MONTGOMERY COUNTY HISTORIC PRESERVATION COMMISSION
STAFF REPORT

Address:	5537 Lambeth Rd., Bethesda	Meeting Date:	3/26/2025
Resource:	Contributing Resource Greenwich Forest Historic District	Report Date:	3/19/2025
Applicant:	Matt Felts & Dane Grossnickle (Cindy McClure for the Levine Group, Agent)	Public Notice:	3/12/2025
Review:	HAWP	Tax Credit:	No
Permit No.:	1107099	Staff:	Laura DiPasquale
Proposal:	Partial demolition; construction of rear and side additions and screened porch

STAFF RECOMMENDATION

Figure 4: Proposed site plan showing the proposed addition dimensions, side and rear setbacks, and tree survey.

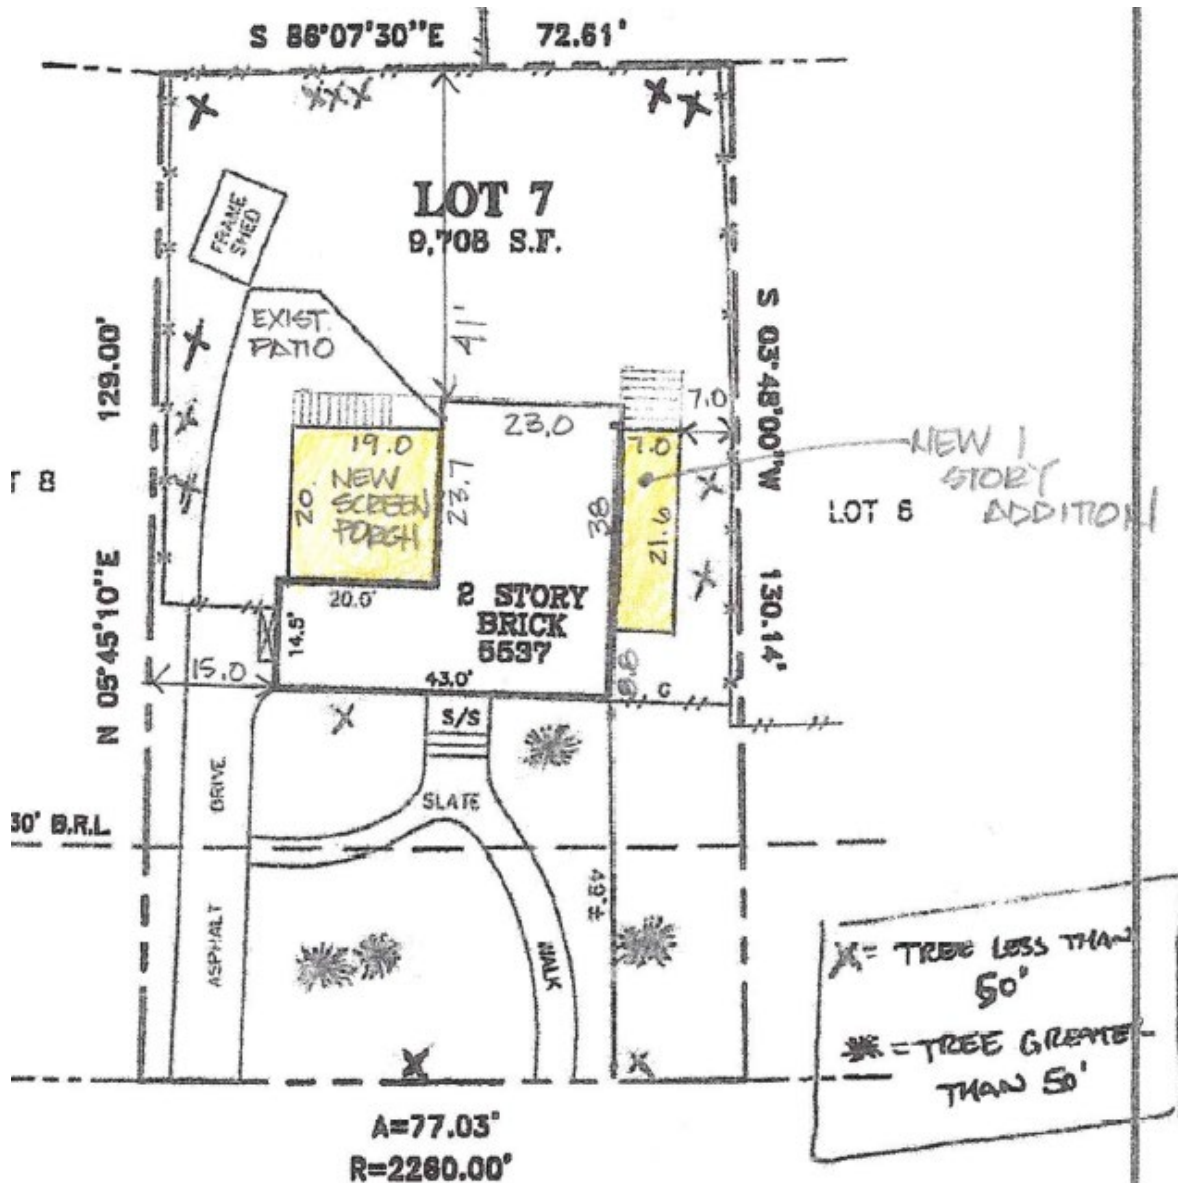
1. The applicant must submit an arborist report showing that the trees adjacent to the proposed east side addition will not be negatively impacted by the proposed footings.
2. All Versatex and Azek trim must be smooth finish and painted.

The *Guidelines* stipulate that rear additions and non-forward facing portions of side additions will be subject to moderate scrutiny, while front-facing portions of additions that extend beyond the sides of the existing structure are subject to strict scrutiny. In terms of size and scale, according to *Guideline D5*, the total lot coverage of a house may not exceed 25% of the lot area and that additions should try to preserve ample spacing between houses. The applicants identify the existing lot coverage as 12% and the proposed as 15%. *Guideline D5* also specifies appropriate setbacks for addition, requiring that the combined total of the two side lot setbacks must be at least 18 feet, with no less than 7 feet on one side. Staff finds that the proposed project complies with these setbacks—with the existing east side lot setback being approximately 14 to 15 feet, the proposed 7-foot-wide addition will leave a side setback of 7+ feet. No changes are proposed to the west side lot setback of 14 feet, creating a total side lot set back of 21 feet and exceeding the minimum 18-foot side yard setback total. The additions do not extend beyond the plane of second floor of the existing rear addition, which is approximately 41 feet from the rear property line, in excess of the 25-foot rear setback requirement.

Figure 9: Proposed porch details (left) and flooring material (right).

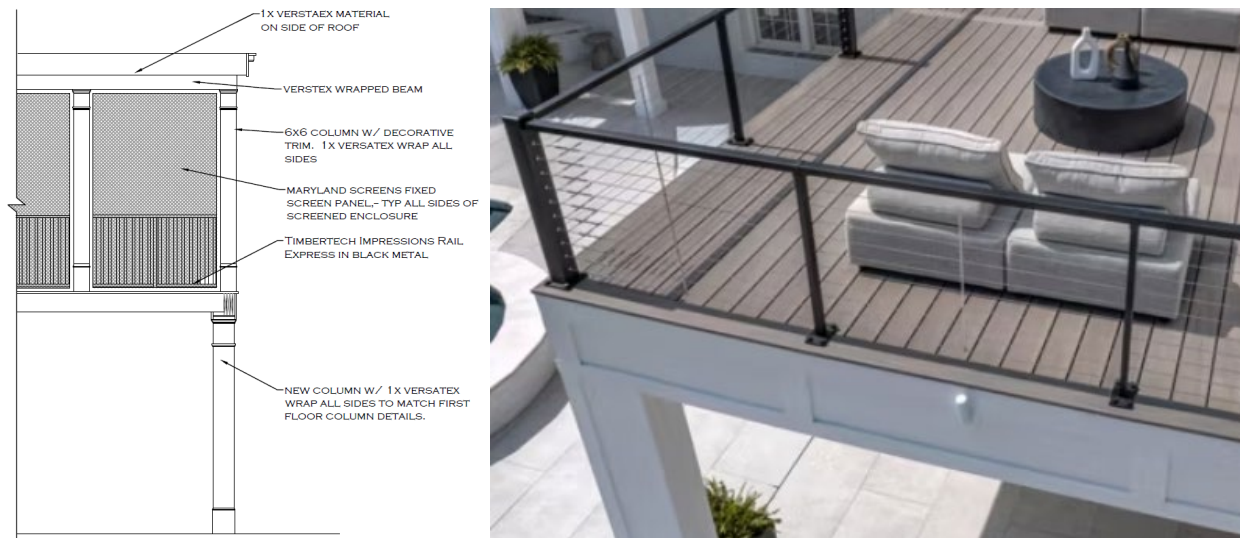
Regarding the proposed screened porch flooring, the HPC’s *Policy* states that porch floors on “Contributing” resources may be of “compatible substitute materials,” and identifies several criteria for such materials. The proposed Trex screened porch flooring satisfies some, but not all of these criteria. The proposed material will be millable, has a uniform appearance consistent with painted wood, will have a smooth texture, and a finished one-inch edge that appears as a cut solid board; the ends of the boards themselves will not be visible. Staff notes that the proposed rear porch will have limited visibility from the public right-of-way, visible only obliquely from the west along Lambeth Road. The majority of the flooring itself will be completely invisible from the public right-of-way and concealed within the screened porch. The one-inch finished edge of the flooring will be visible over the smooth, painted Versatex or Azek fascia board below. Staff finds that the proposal partially complies with the *Policy*, but that, pursuant to Chapter 24A-8(b)(2), the proposal will not substantially alter the exterior features of the historic resource. Staff further finds that the proposed porch will be compatible with but differentiated from the historic house, and if removed in the future, will leave the essential form and integrity of the property intact, in keeping with *Standards* 9 and 10.
